From: David Fuller [REDACTED]
Sent: 17 June 2015 11:01
To: Ross Leal
Cc: Sophie Masson; AFA Fuller
Subject: Russet House - K/17/15/HH - Response to objections

From: David Fuller [REDACTED]
Date: 1 June 2015 09:52:51 GMT+01:00
To: Ross.Leal@arun.gov.uk
Cc: AFA Fuller [REDACTED]
Subject: K/17/15/HH - Russet House, Gorse Avenue, Kingston Gorse

Job Title	
Russet House, Kingston Gorse	
Client	
Miss S Masson	
Drawing Name	
Driveway & Landscaping Plan	
Drawing Status	
Planning	
Drawn by	DF
Date	June 15
Checked by	Date
Drawing Scale	
1:100 at A1	
Drawing No	Status Revision
15753/ 07

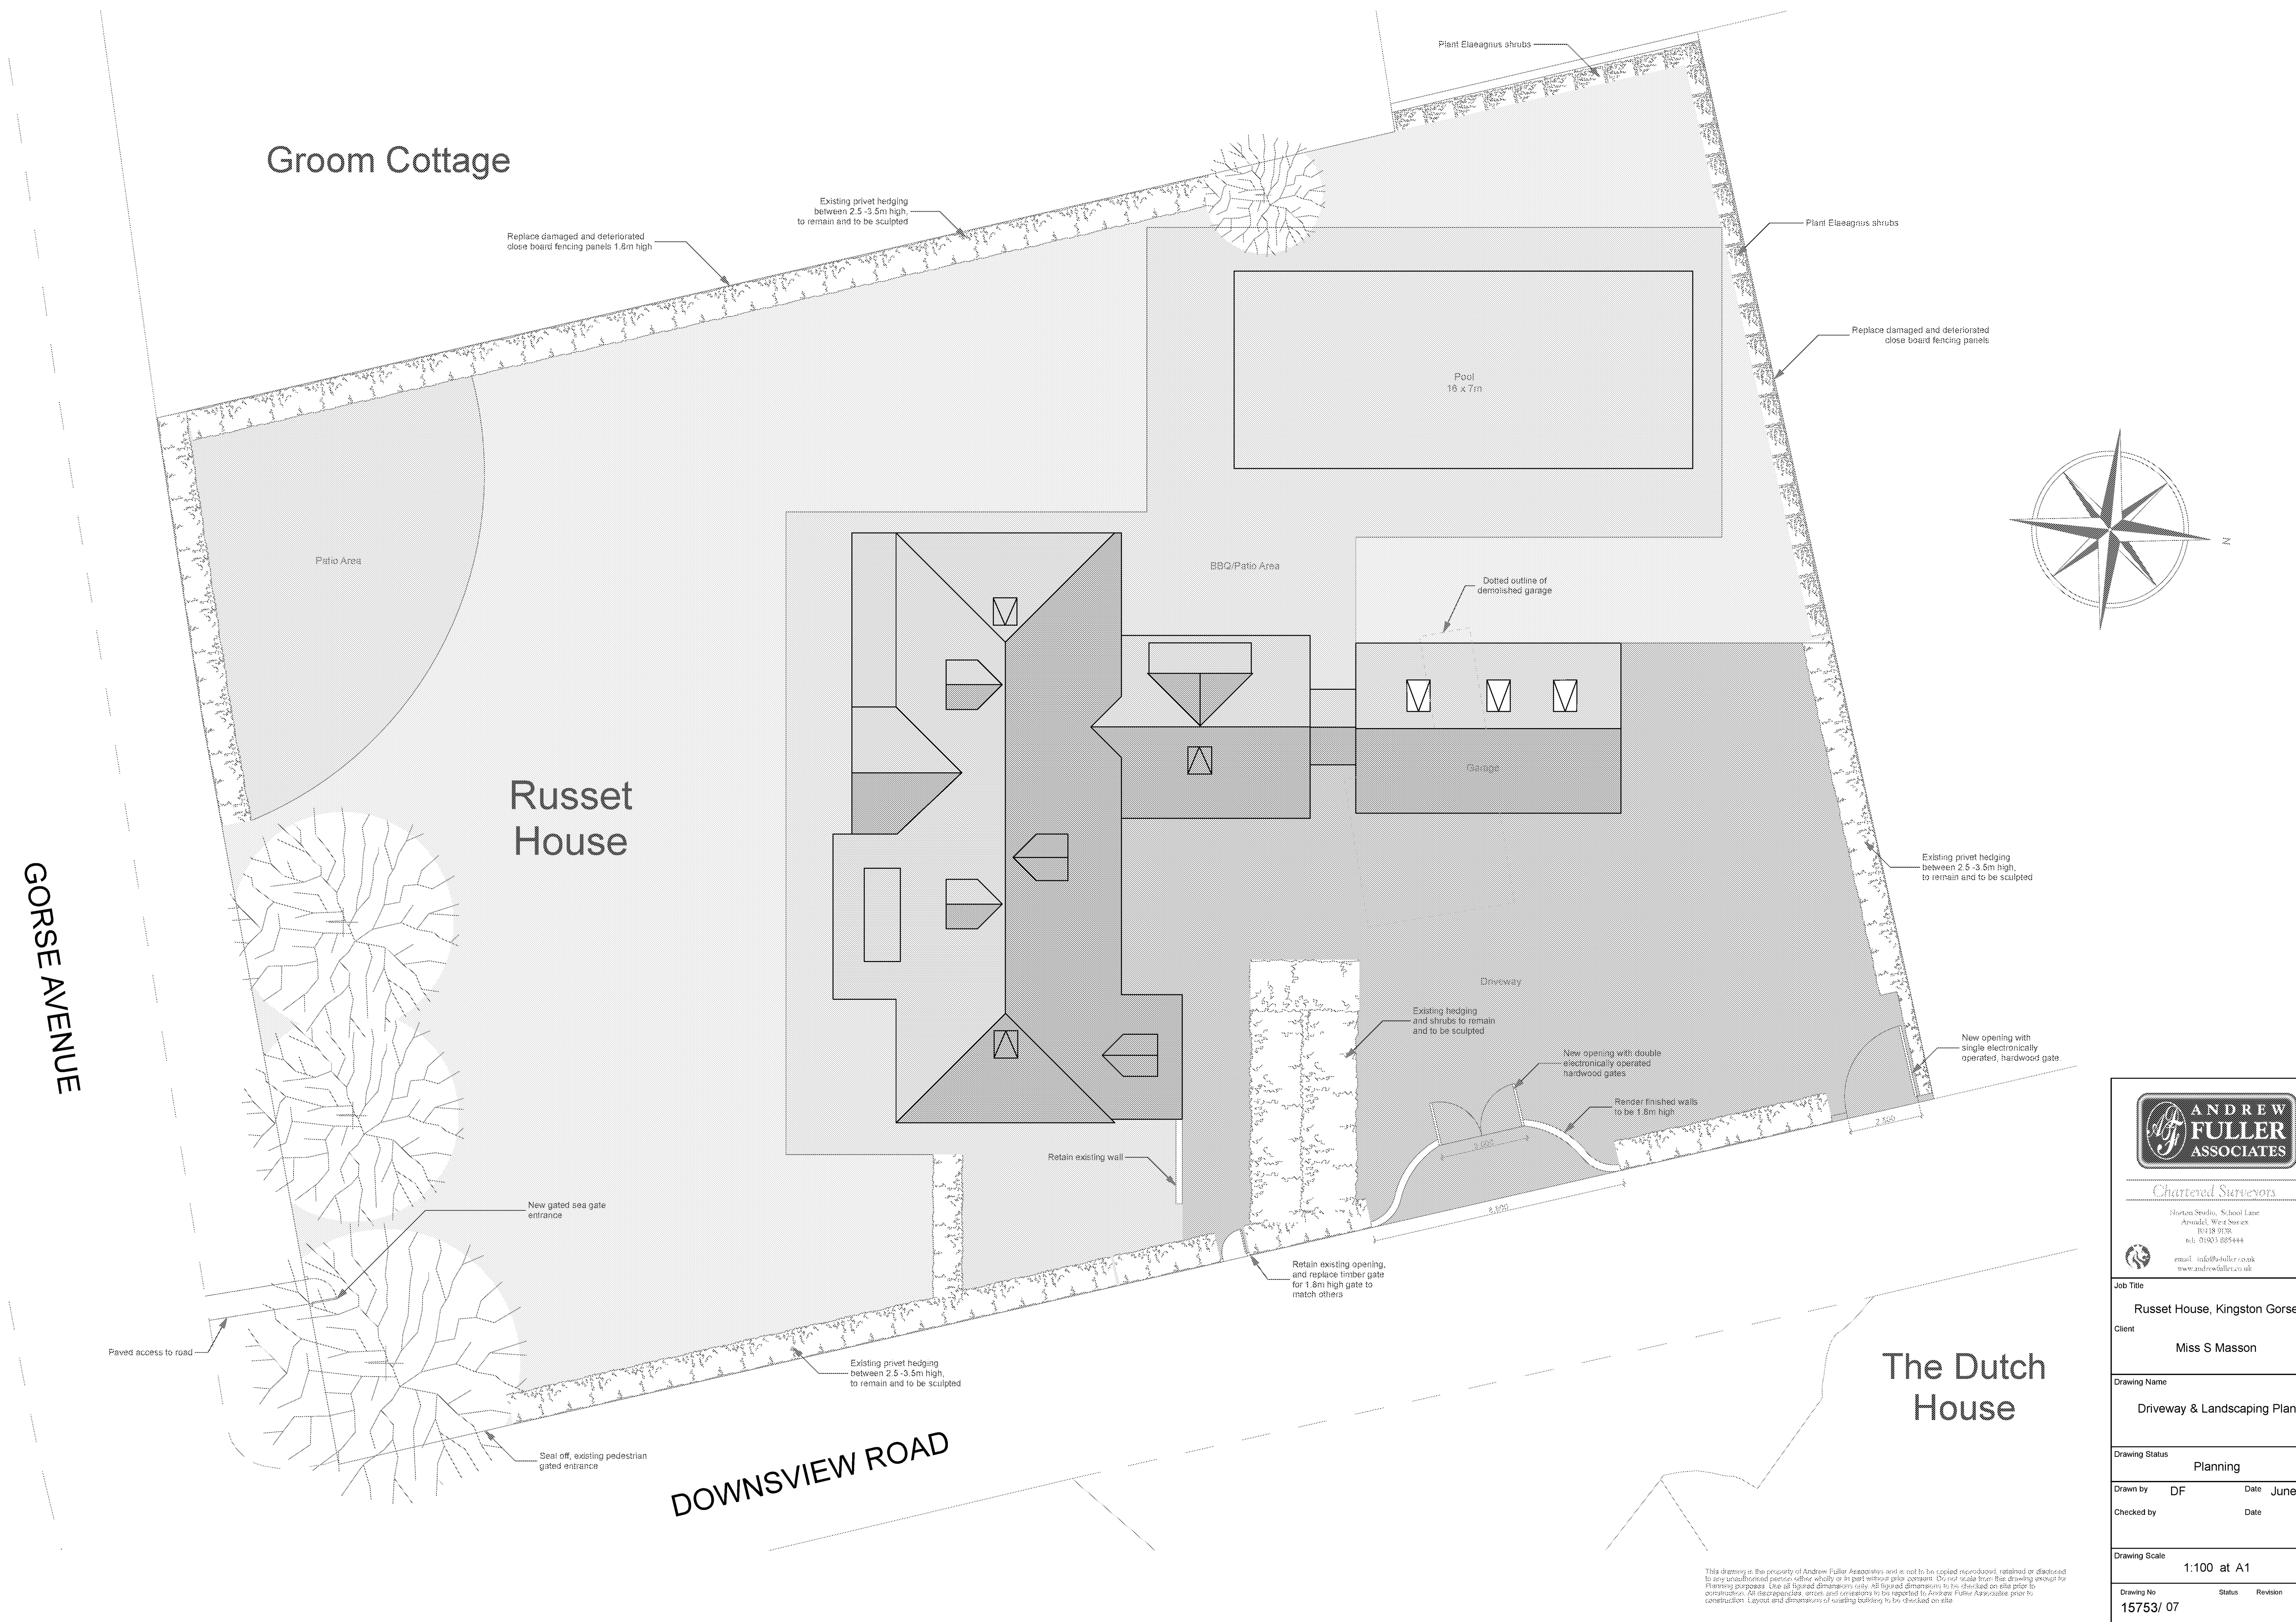
- 3) Mr & Mrs Bridgwater - The Dutch House (Immediately to the Northeast of Russet House) - have objected to the speculated enlargement of the driveway entrance to Russet House. Please see the attached drawing number 15753/07, detailing the driveway, landscaping and boundary treatments. We hope this will alleviate Mr and Mrs Bridgwater's concerns, as the driveway is only slightly enlarged from that of the existing opening, however is recessed and is similar to what they have created at The Dutch House. Just to confirm, the recessed driveway will be advantageous from a highways perspective as it will allow vehicular movements in and out of Russet House to be achieved without the creation of risk to those traversing along Downsview Road. Furthermore, the additional parking provision from the enlarged internal driveway, will eliminate any necessity for parking on Downsview Road, and will improve manoeuvrability.
